Proposal Request ^{6 Rev 1}

Project: 1316-LFUCG PSOC

Subject: Gas Line Connection to Existing

SITE UTILITY PLAN
LFUCG PUBLIC SAFETY OPERATIONS CENTER
PHASE 1B - RENOVATION

C1.2

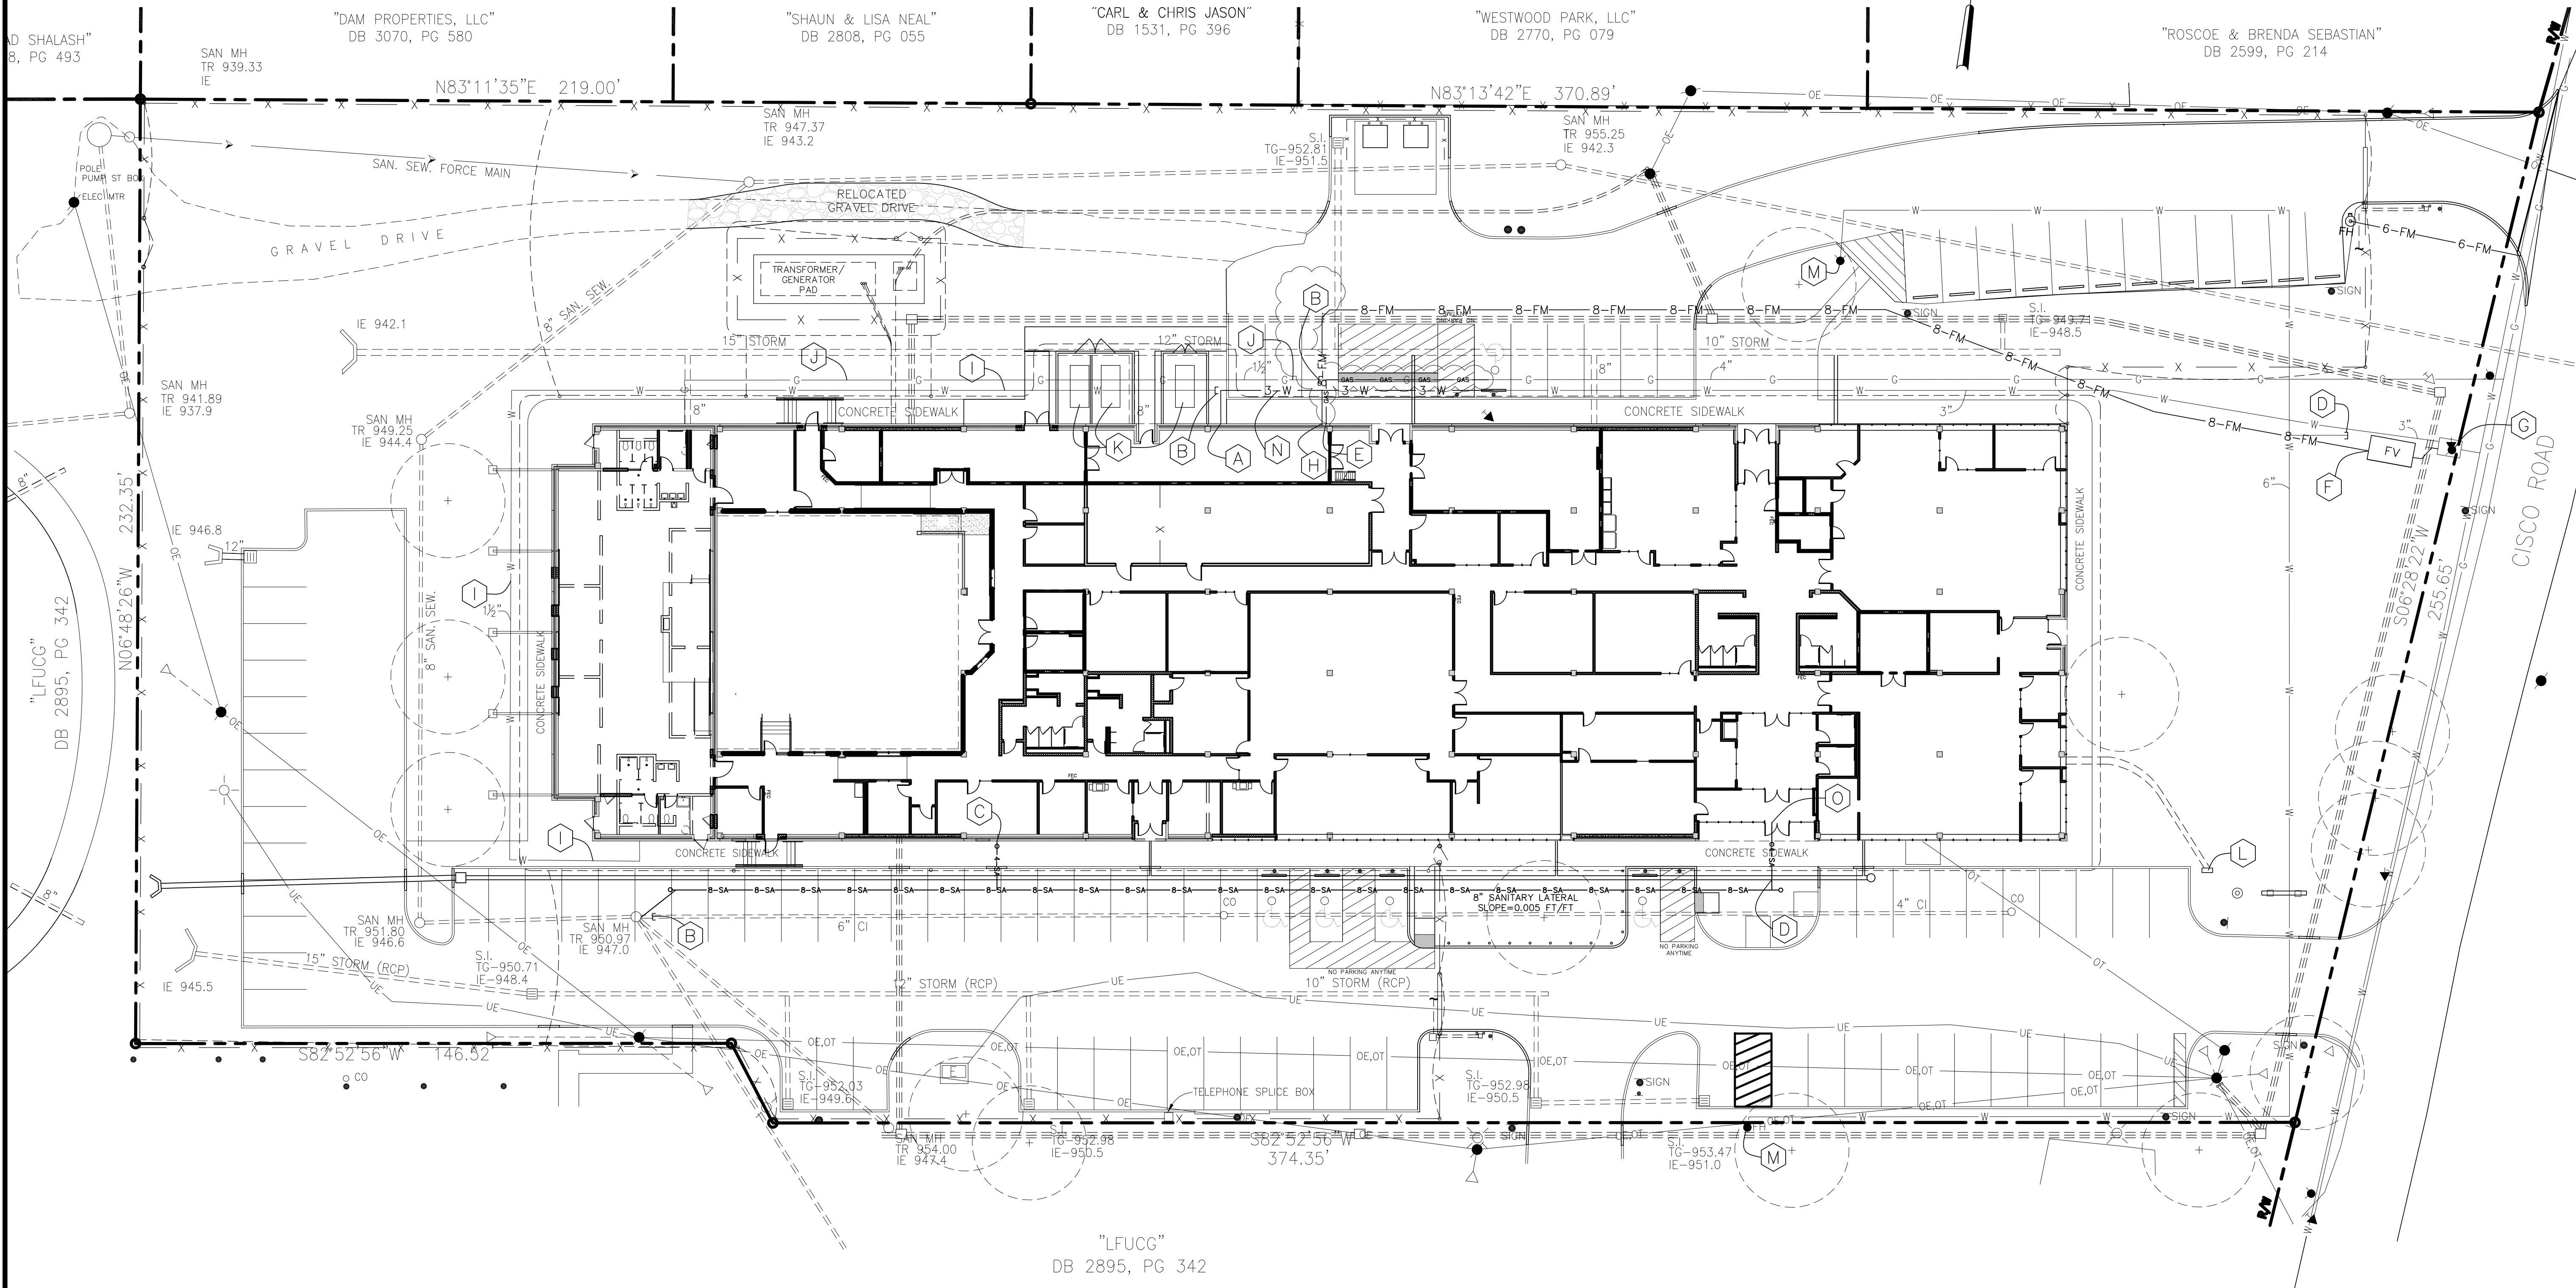
Per the attached revised utility plan. Contractor shall install a 2 ½" gas line; extended from the building to the connection point where the existing 4" gas main ends. This is approximately 40' from where the gas line enters into the building.

- (D) MAINTAIN MINIMUM 3 INCHES OF CLEARANCE FROM BOTTOM OF STORM HEADER PIPE TO TOP OF SANITARY SEWER LATERAL
- (E) CONTRACTOR TO INSTALL NEW 2 1/2" GAS LINE FROM RISER LOCATION TO EXISTING 4" LINE. (SEE MECHANICAL DRAWINGS FOR CONTINUATION INTO BUILDING)

1. Sketch (LFUCG Elevation of North Wall in EOC 129)
2. RFI 76

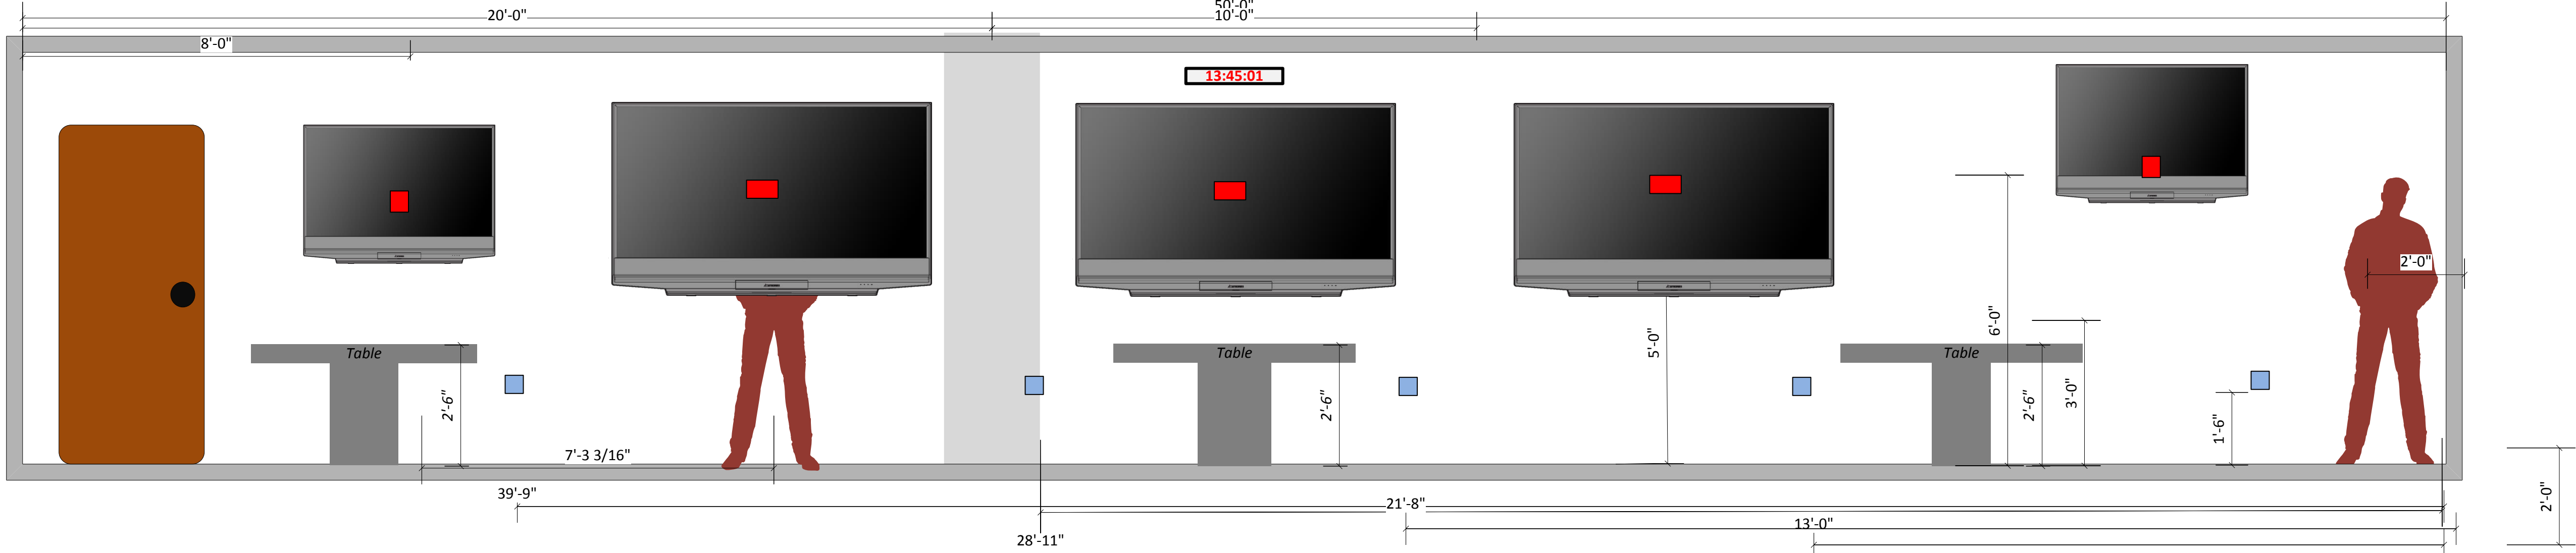
The Contractor shall provide a proposal to furnish and install (2) additional receptacles and (2) additional data drops required for the (2) added television monitors in EOC 129 (North Wall). Rough-ins shall be located as shown on the attached Sketch provided by MCP.
